Aldgate to Hainault Quietway - H10

From: [REDACTED]
To: [REDACTED]
Cc: [REDACTED]
Subject: RE: H10 presentation
Date: 19 November 2014 08:57:08
Attachments: [image001.png](#)
[Wallis Road Bridge \(H10\) Ramp Presentation \(Draft\) 141117.pdf](#)

WALLIS ROAD BRIDGE (H10) TEMPORARY CYCLE RAMP PROPOSAL

Figure 13 Option 2b measurements & Proposals

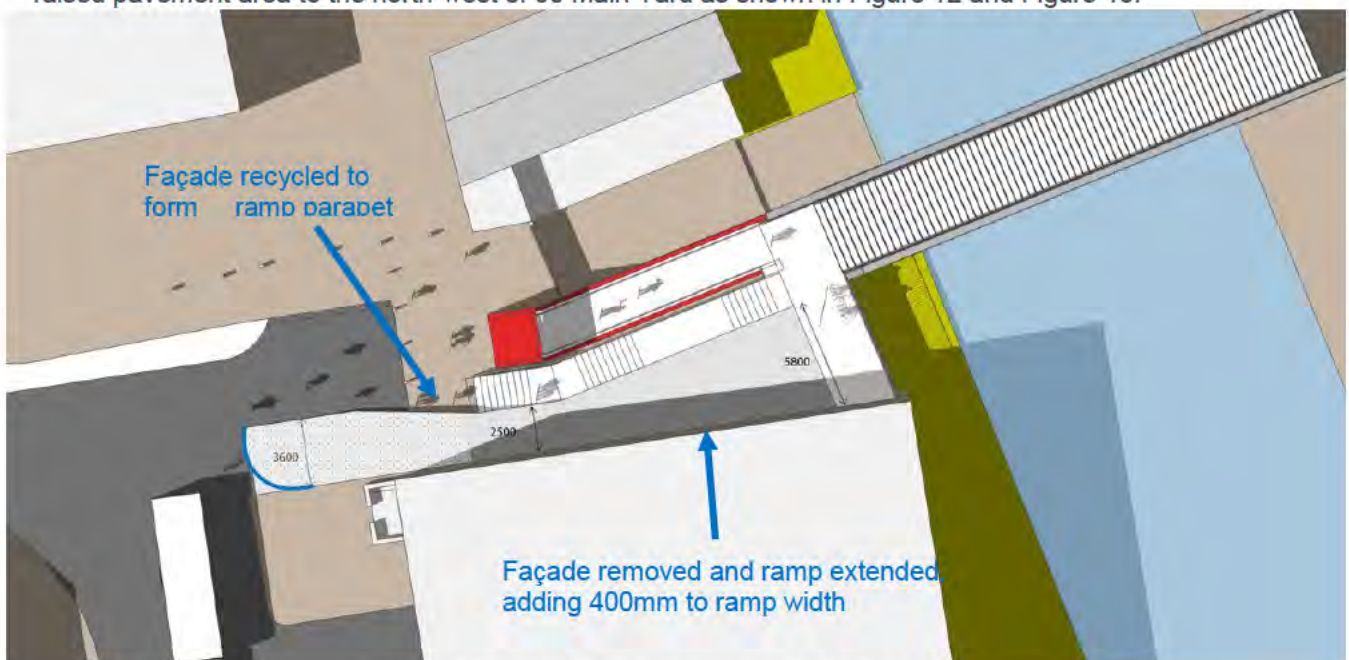
- Are the images showing the ramp options to scale?
- Can you confirm if Atkins have any other plans/drawings of the preferred option (2b) or is what is contained in the feasibility report everything they have done?

May 2015- draft proposed design developed to address safety audit and public realm issues:

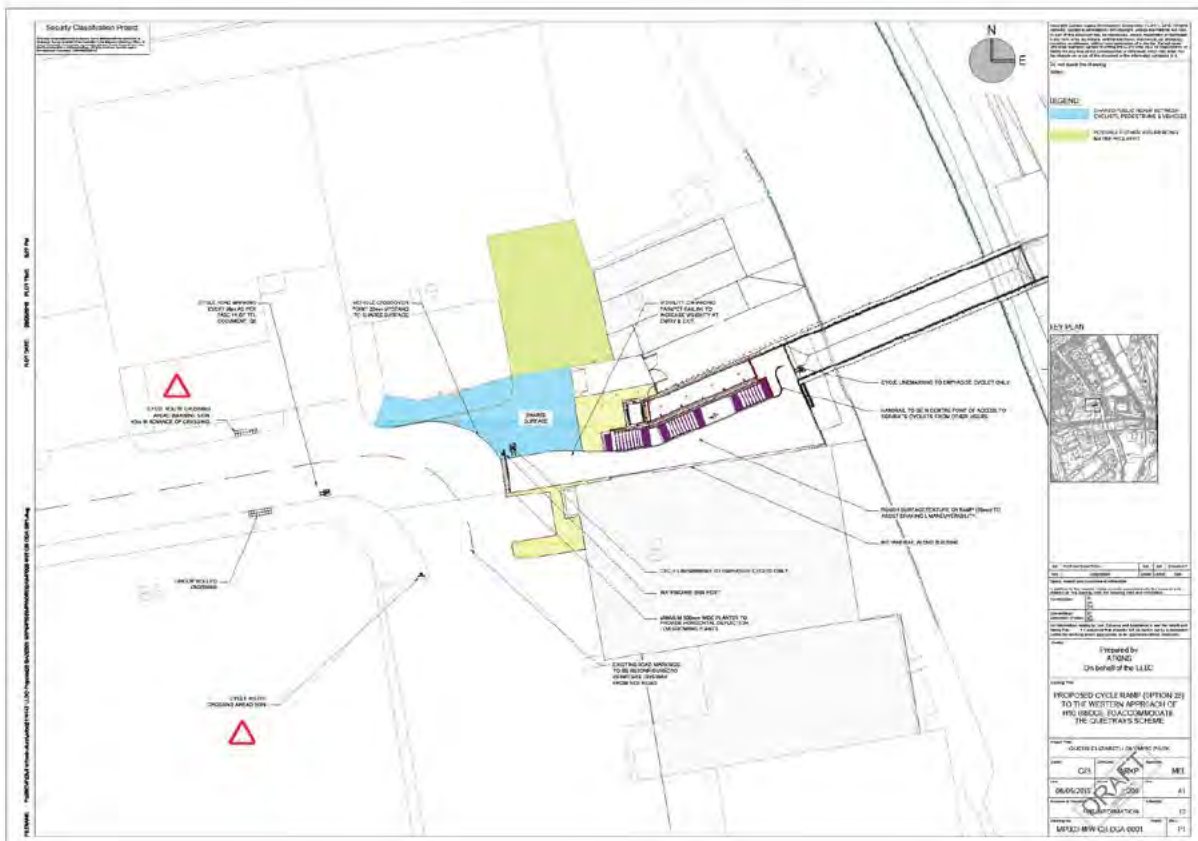
Items raised by safety audit- December 2014		Design response
2.1	Risk of ramp users losing control and falling due to excessive gradient and absence of intermediate landings	Not able to mitigate risk as fixed gradient
